MITIGATION PLAN

**Morgan Branch Restoration Site
Buncombe County, North Carolina
RFP# 16-007724 (Issued: 3/1/19)
DMS Project Number 100127
DMS Contract 7909
USACE Action ID: SAW-2018-01163
DWR #: 20181030**

Re: NCIRT Review and USACE Approval of the NCDMS Morgan Branch Mitigation Site /
Buncombe County

USACE ID: SAW-2018-01163
NCDMS Project # 100127
NCDWR # 2018-1030 v1

**FIGURE 9. PROJECT ASSET MAP
TYPE AND EXTENT
MORGAN BRANCH RESTORATION SITE
BUNCOMBE COUNTY, NC**

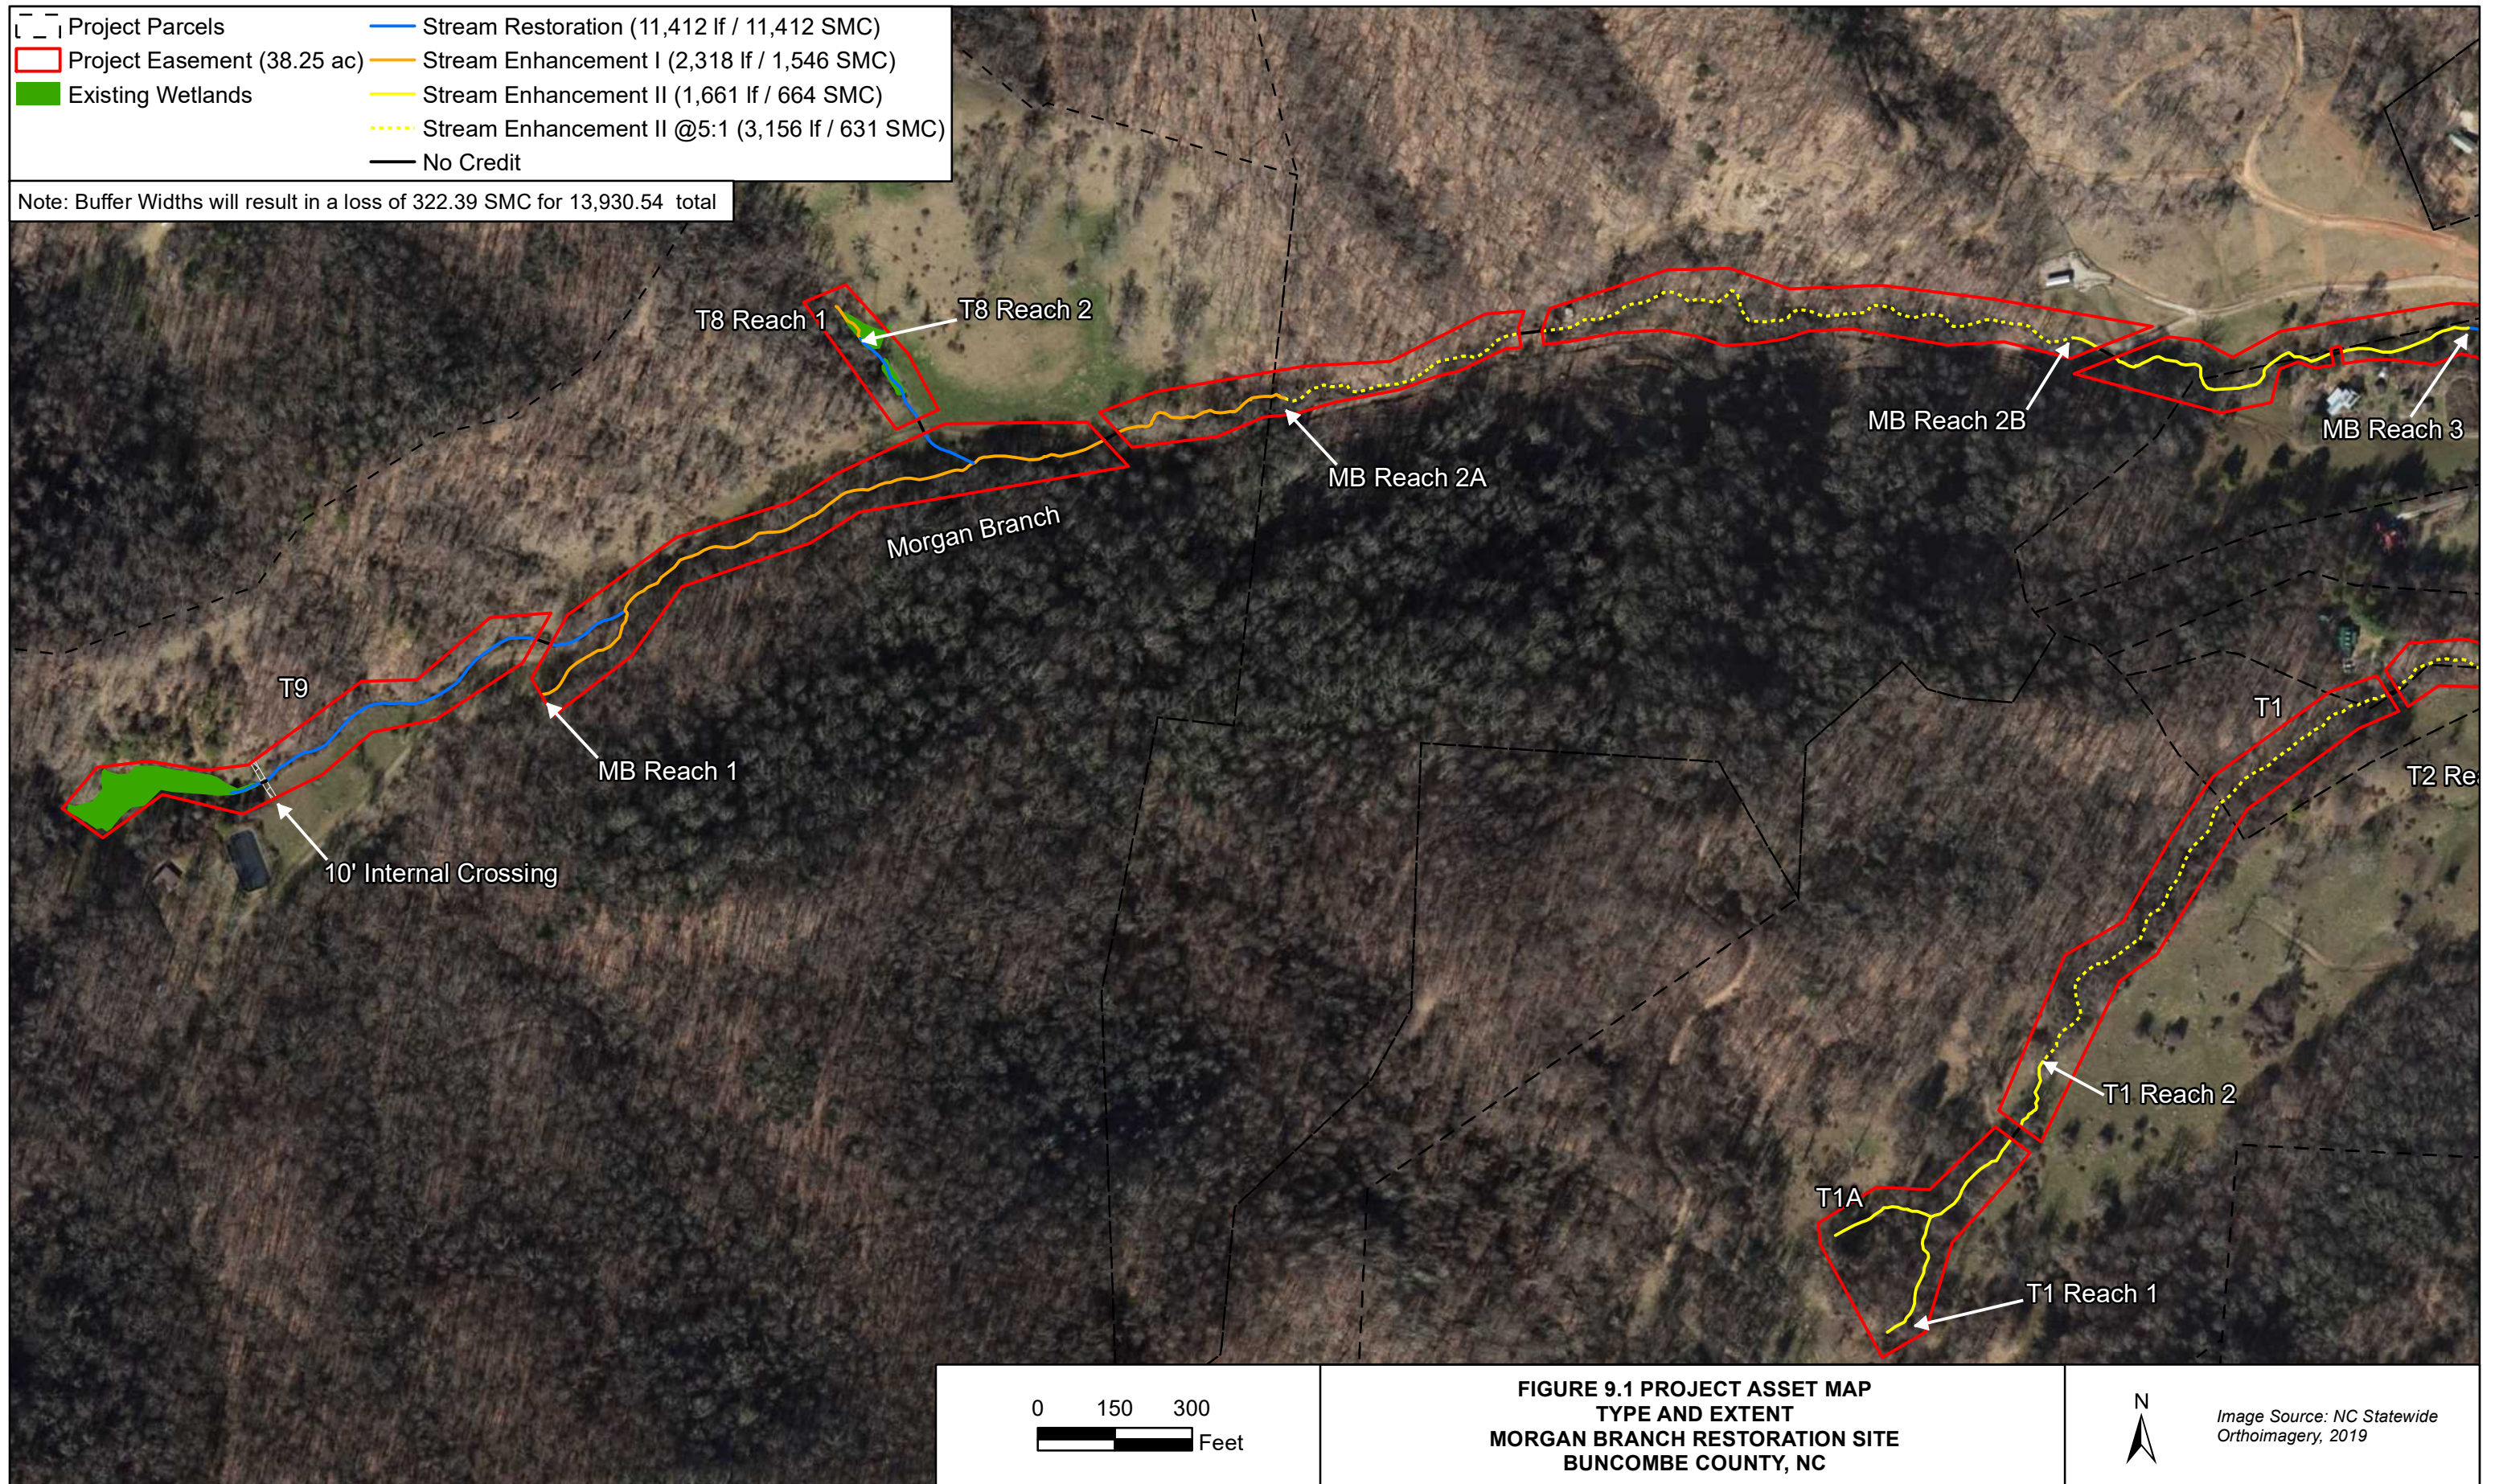
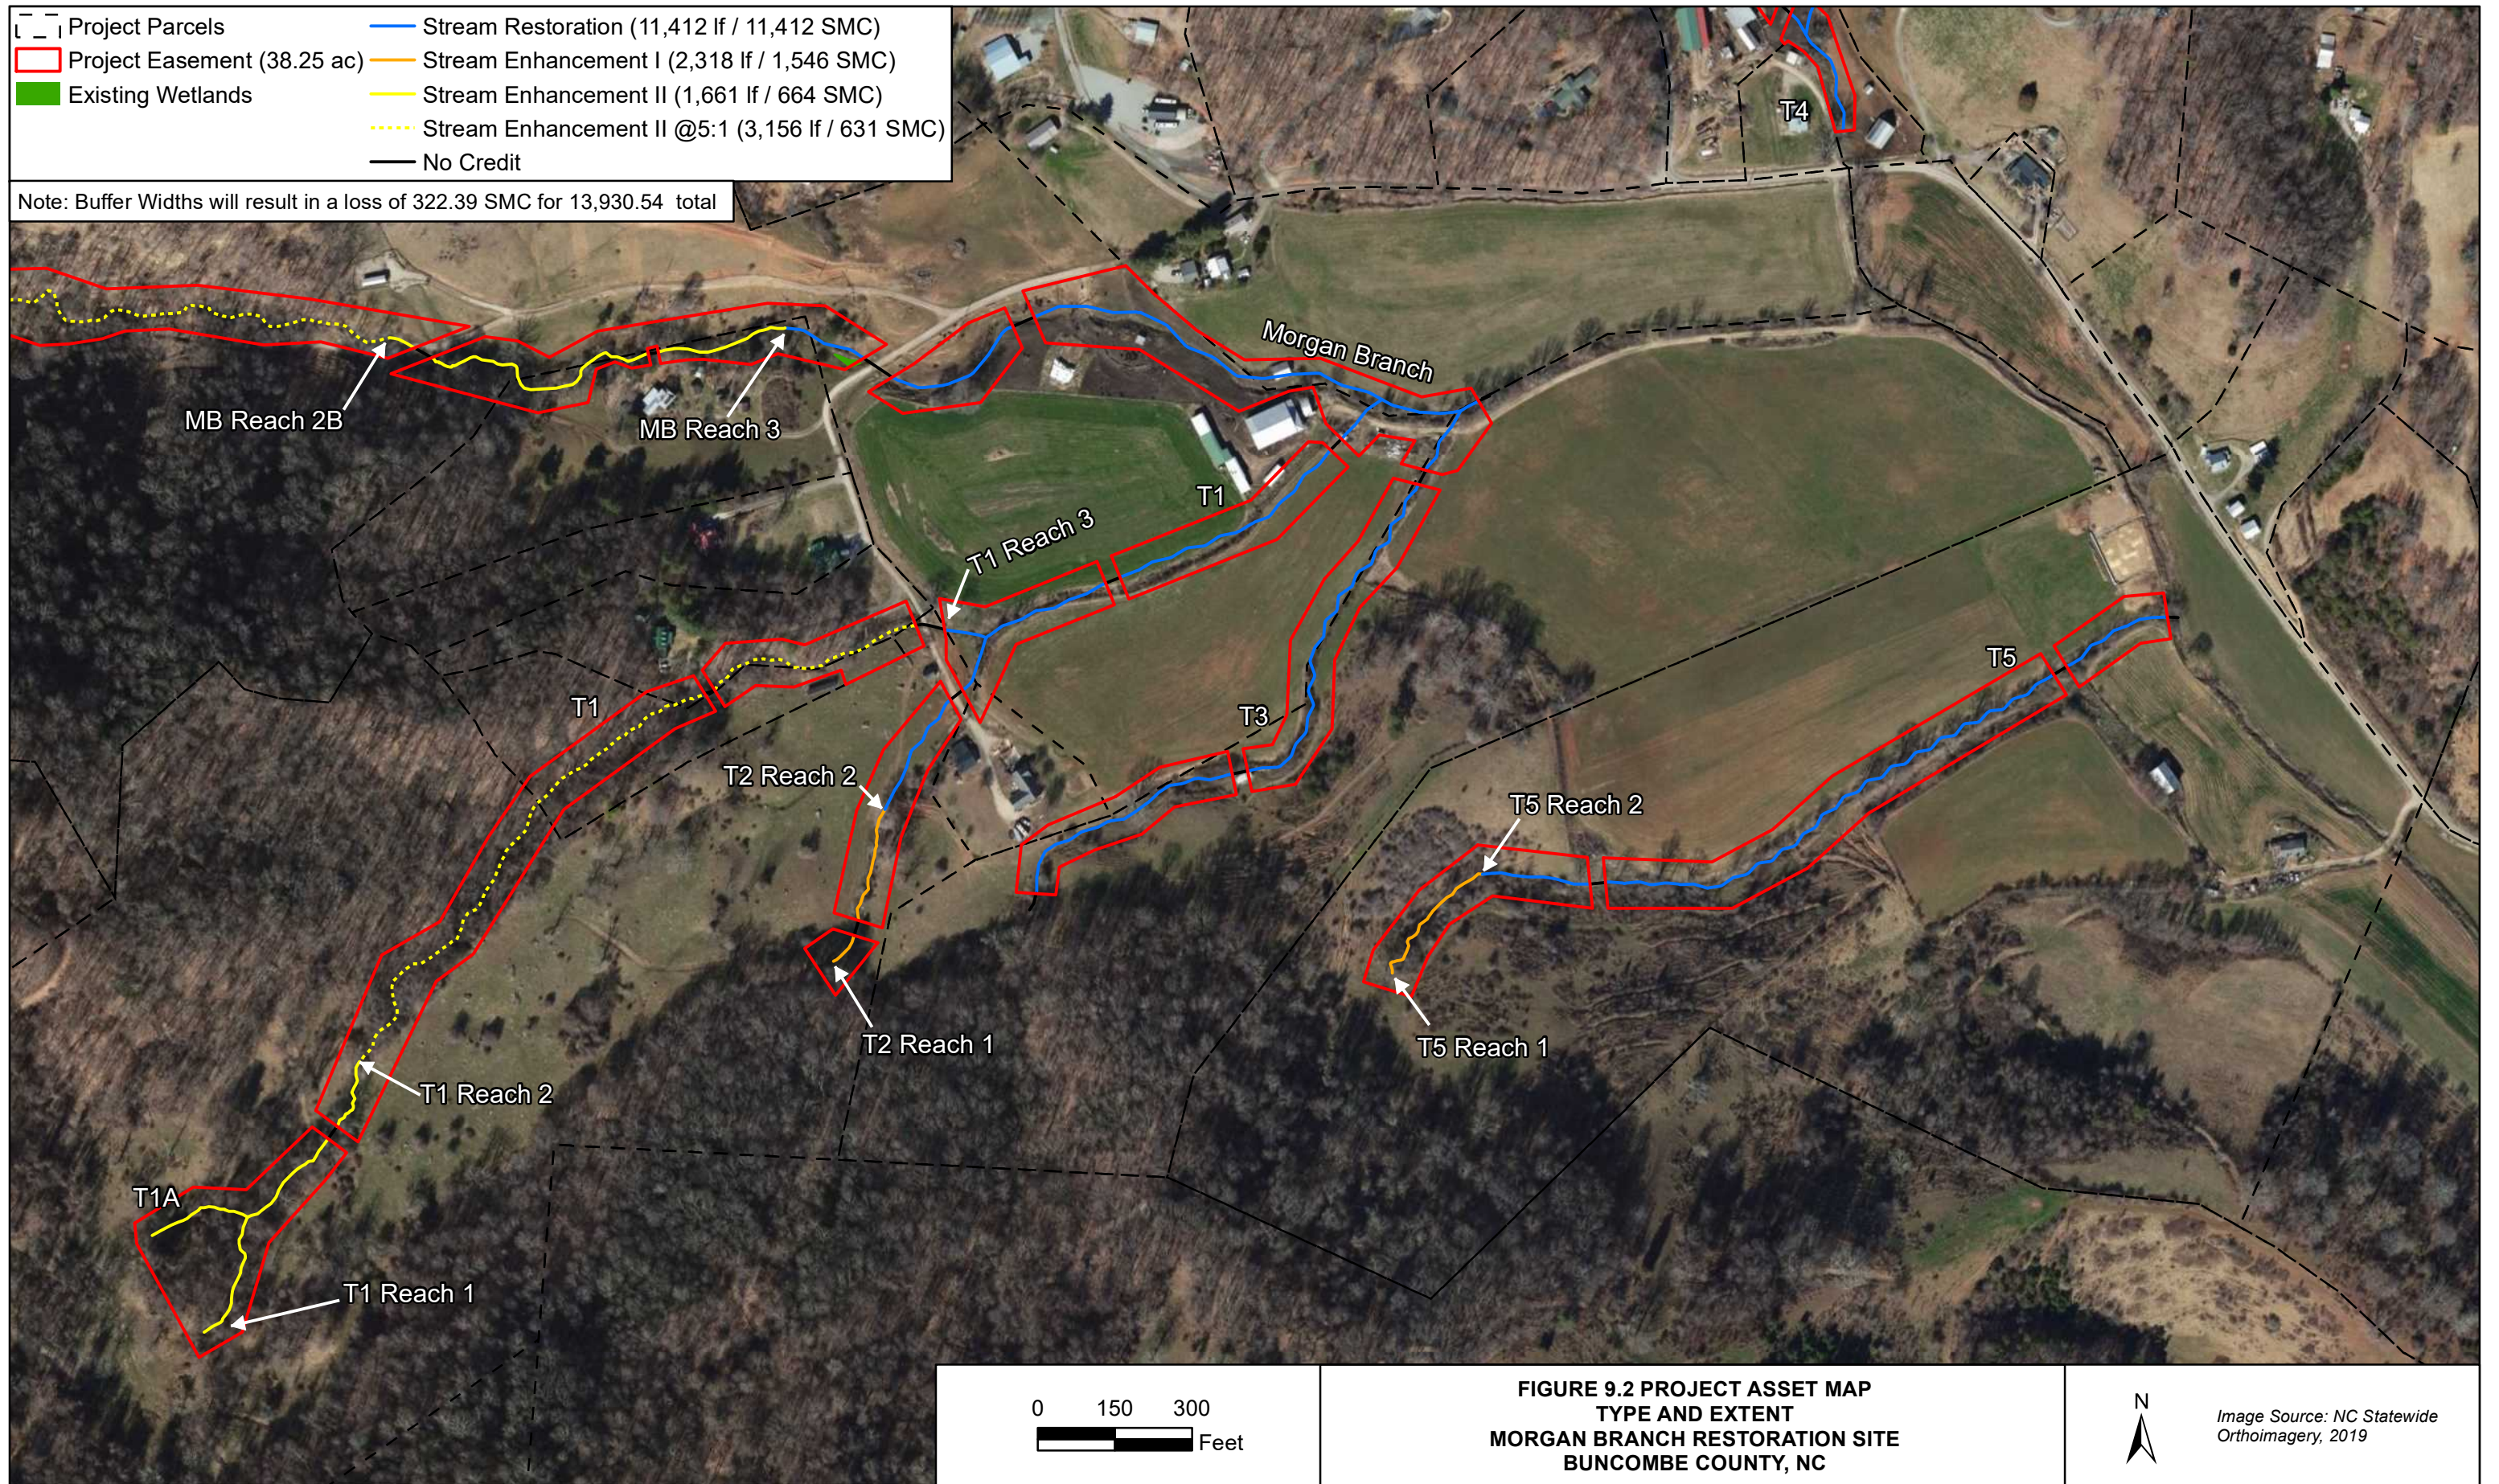
13. Please add the existing project wetlands to Figures 9 and 10. These figures (especially Figure 10) should be split into multiple sheets at a more viewable scale.
